L-PI-12-007  
10 CFR 50.90

Prairie Island Nuclear Generating Plant Units 1 and 2  
Dockets 50-282 and 50-306  
Renewed License Nos. DPR-42 and DPR-60

Supplement to License Amendment Request (LAR) to Add Diesel Fuel Oil License Bases and Revise Technical Specifications (TS) 3.7.8, "Cooling Water (CL) System" and 3.8.3, "Diesel Fuel Oil" (TAC Nos. ME6849 AND ME6850)

Response to Requests for Additional Information (RAIs) for License Amendment Request (LAR) to Add Diesel Fuel Oil License Bases and Revise Technical Specifications (TS) 3.7.8, "Cooling Water (CL) System" and 3.8.3, "Diesel Fuel Oil" (TAC Nos. ME6849 AND ME6850)

NF-39232, "Flow Diagram Fuel & Diesel System Unit 1 & 2", Revision 80

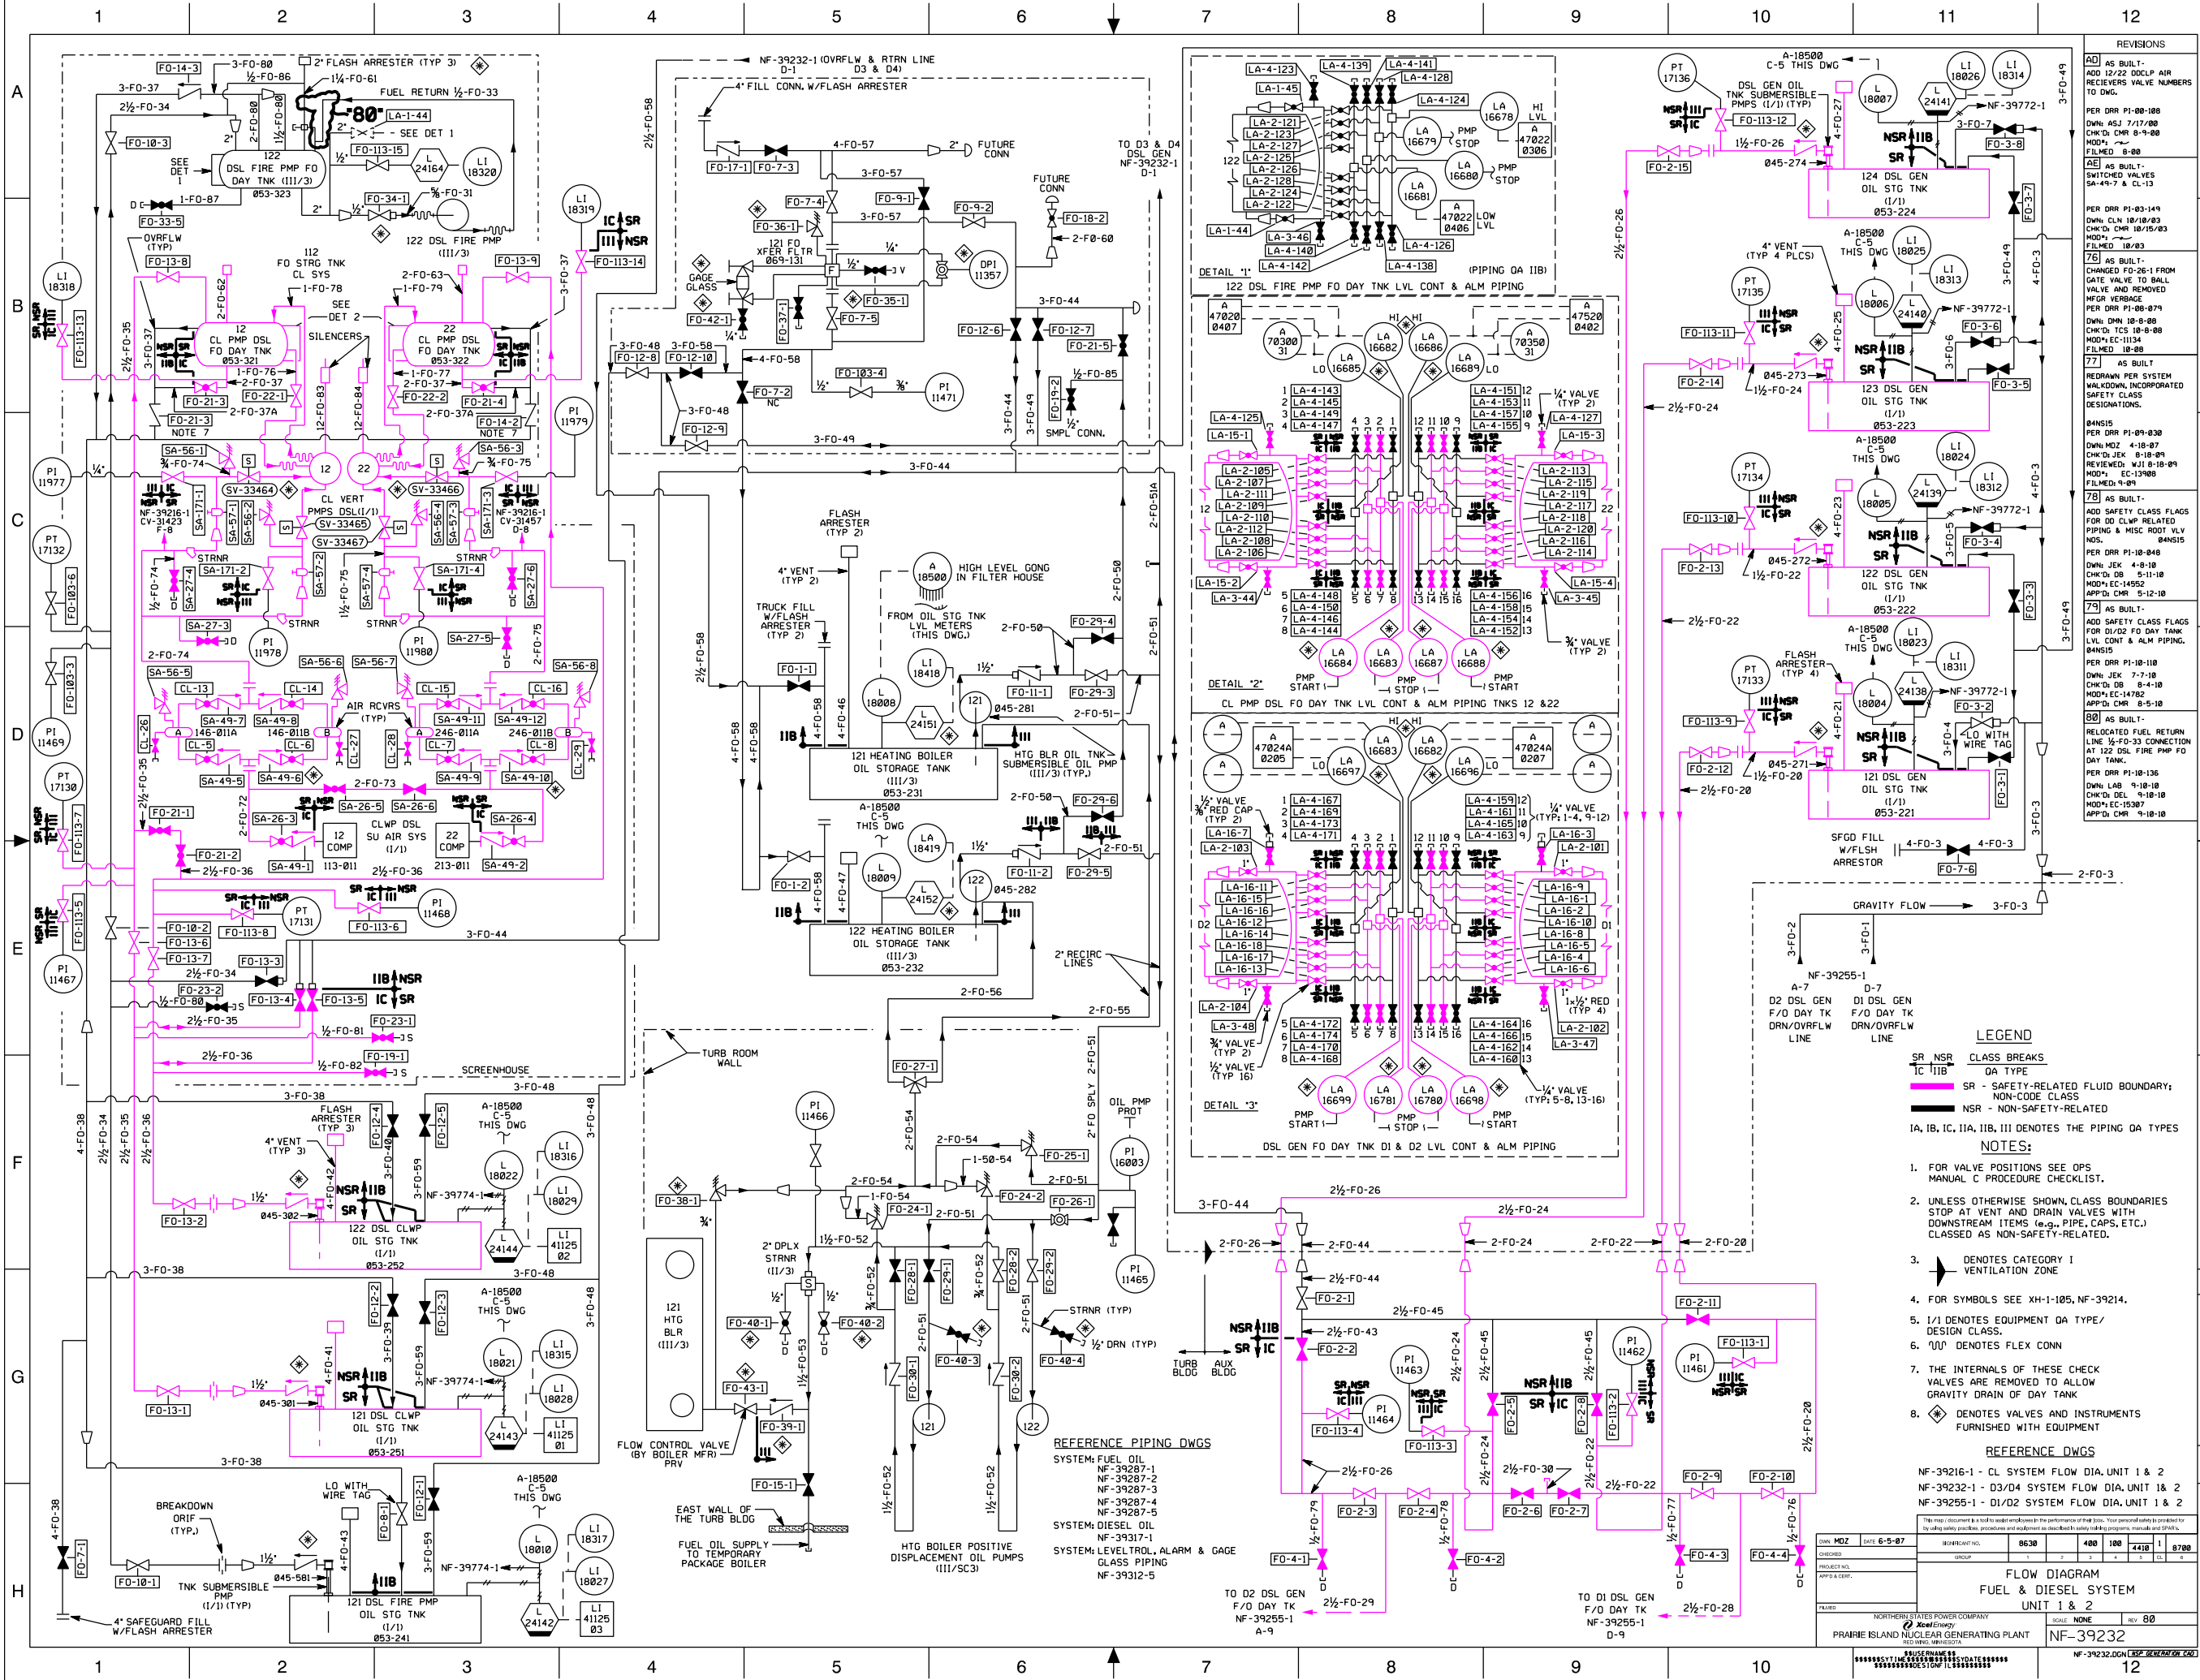
The LAR states that six Design Class I fuel oil storage tanks supply fuel oil to the two Unit 1 EDGs (D1/D2) and the two diesel driven cooling water pumps (DDCLPs). Each tank is equipped with a transfer pump to pump fuel from the tank to the nominal capacity 500 gallon day tank of either EDG or either DDCLP. The six tanks are interconnected such that any tank can be manually aligned to supply any diesel day tank and any combination of the six tanks can be used to meet the 14 day storage capacity requirement for a probable maximum flood. Please provide the following information:

- a) A flow diagram depicting the interties between the tanks and EDGs D1/D2 and the two DDCLPs, including valves that are required to operate for aligning the tanks. Identify the normal alignment required to satisfy TS requirements.
- b) Identify tanks and components that may be unavailable during routine and major maintenance activities and associated limiting conditions for operation (LCOs) that are applicable during the maintenance activities.
- c) Provide a detailed discussion on the power sources for each of the components required to align the fuel oil system for 14 day operation.
- d) Identify and provide a detailed discussion on the procedures that are used to validate each of the paths required to transfer fuel for 14 day operation of the EDGs and the DDCLPs.

See Attachment 1 to this Enclosure, flow diagram NF-39232, "Flow Diagram Fuel & Diesel System Unit 1 & 2", Revision 80. The normal flow path to satisfy TS requirements (provided as drawing equipment and pipe designations) follows:
